<b>ST. CHARLES</b> <small>SINCE 1834</small>	<b>HISTORIC PRESERVATION COMMISSION</b>		
	<b>AGENDA ITEM EXECUTIVE SUMMARY</b>		
	<b>Agenda Item Title/Address:</b>	COA: 520 Indiana St.	
	<b>Proposal:</b>	Addition- change to door and windows	
<b>Petitioner:</b>	Zach Derrico		
<b>Please check appropriate box (x)</b>			
	<b>PUBLIC HEARING</b>		<b>MEETING 9/21/16</b>
			<b>X</b>
<b>AGENDA ITEM CATEGORY:</b>			
<b>X</b>	Certificate of Appropriateness (COA)		Façade Improvement Plan
	Preliminary Review		Landmark/District Designation
	Discussion Item		Commission Business
<b>ATTACHMENTS:</b>			
Minutes from 8/17/16 Elevations and floor plans Previously approved elevations			
<b>EXECUTIVE SUMMARY:</b>			
<p>The Commission approved a COA for an addition to the house on 8/17/16.</p> <p>Two modifications to the approved plans are now proposed:</p> <ol style="list-style-type: none"> <li>1. Change one of the single doors on the north elevation to a double door.</li> <li>2. Change the new windows on the second floor of the north elevation to casement windows.</li> </ol>

**6. COA: 520 Indiana St. (addition)**

Proposed Addition for  
520 W. INDIANA STREET  
ST. CHARLES IL. 60174

**SECOND FLOOR PLAN - REMODEL**  
SCALE: 1/4" = 1'-0"

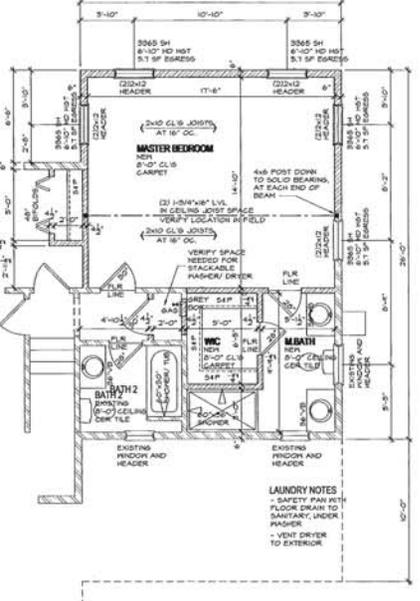
Dr. Smunt noted the proposed windows appear to be a wider and have a different proportion than the existing windows in the house. Mr. Derrico said he can utilize the same dimension windows in the addition.

Dr. Smunt asked about the placement of the windows on the east elevation. Mr. Derrico said he may eliminate the new window near the chimney. Dr. Smunt said if that is the case, then the other window should be moved to align with the first floor window below.

**A motion was made by Dr. Smunt and seconded by Mr. Bobowiec with unanimous voice vote to approve the COA with conditions: 1) If the window north of the chimney is omitted, then center the other window over the first floor window, 2) All windows to match existing 2<sup>nd</sup> floor window dimensions, and 3) All materials to match existing.**
